APPLICATION NO.	FILING DATE	FIRST NAMED INVENTOR	ATTORNEY DOCKET NO.	CONFIRMATION NO.
10/583,550	05/21/2007	Giovanni Stefani	292784US6PCT	9838
22850	7590	05/29/2009	EXAMINER	
OBLON, SPIVAK, MCCLELLAND MAIER & NEUSTADT, P.C. 1940 DUKE STREET ALEXANDRIA, VA 22314			MURPHY, TIMOTHY J	
			ART UNIT	PAPER NUMBER
			3656	
			NOTIFICATION DATE	DELIVERY MODE
			05/29/2009	ELECTRONIC

Office Action Summary	Application No. 10/583,550	Applicant(s) STEFANI, GIOVANNI	
	Examiner Timothy J. Murphy	Art Unit 3656

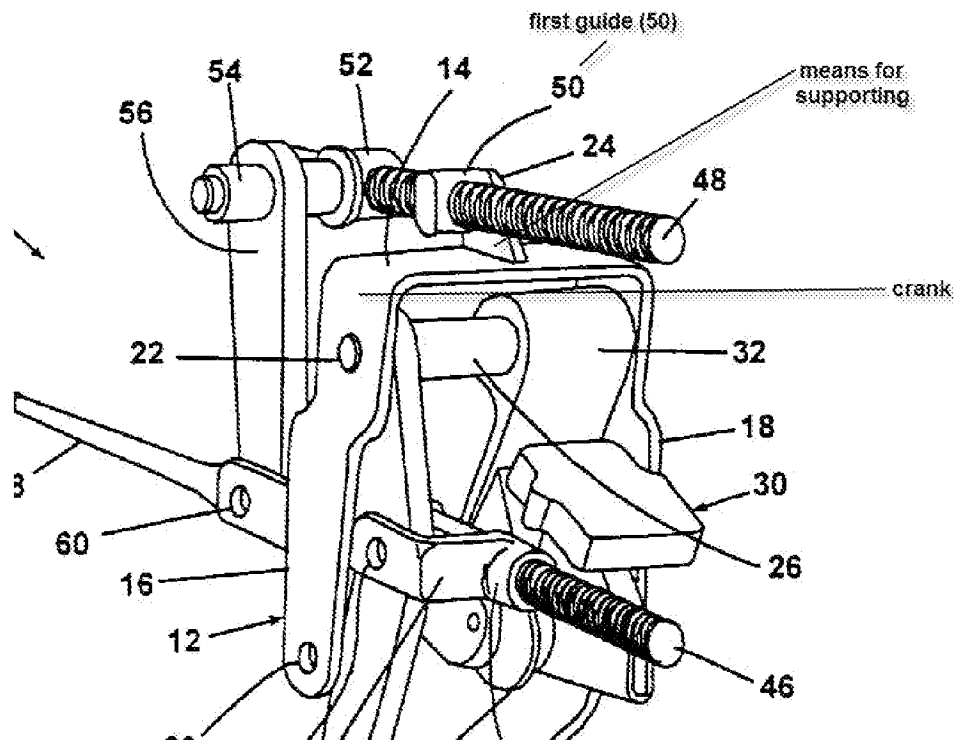
Regarding claim 18, Brock discloses an adjustable set of pedals for a motor vehicle, comprising:

- a first pedal (36 and 38; fig 1) for braking of the motor vehicle;
- a second pedal (31; 34; fig 1) for acceleration of the motor vehicle;
- means for supporting the first and second pedals (see figure below); and

- an adjustment device (fig 1 shows adjustment device for pedals 36, 31) for controlling selectively the position of the supporting means with respect to a frame of the motor vehicle (104; fig 8) and comprising a crank mechanism (cradle 12 acts as a crank between nut 50 and pin 26) set between the supporting means and the frame (fig 8);

- the adjustment device comprising:
 - a first guide (nut 50) extending in a first direction (along 48) and supporting the supporting means (via ear 24) which are mobile along the first guide; and

- a control rod (second ball screw 46 and nut 42) parallel to the first direction, slidably engaged through the first pedal (via 42), and connectable with the first pedal for actuating a braking device of the motor vehicle (via elements 42 and push rod 58)

- wherein the first guide (50) is fixed to the frame and the supporting means are mobile along a rectilinear path (means for supporting are mobile along 48, which is a straight line).
